Product Change Notification

113723 - 00

Change Notification #: 113723 - 00
Change Title: Intel® Server Chassis P4308XXSFEN
PCN 113723-00, Product Design, Label
Update Hard Disk Drive Tray to add 2
latches and labels
Date of Publication: March 23, 2015

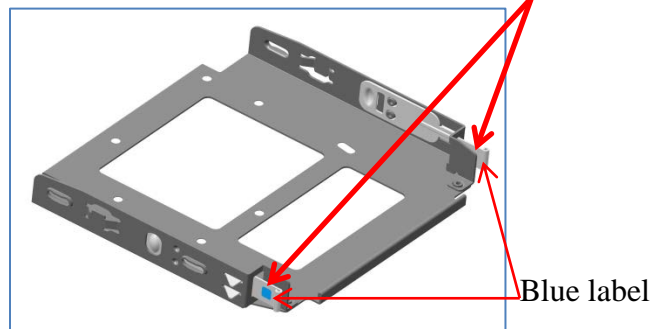
Add two latches and labels for the fixed HDD (Hard Disk Drive) tray to enhance the robustness of the HDD tray and indicate the touch point for the HDD tray assembly.
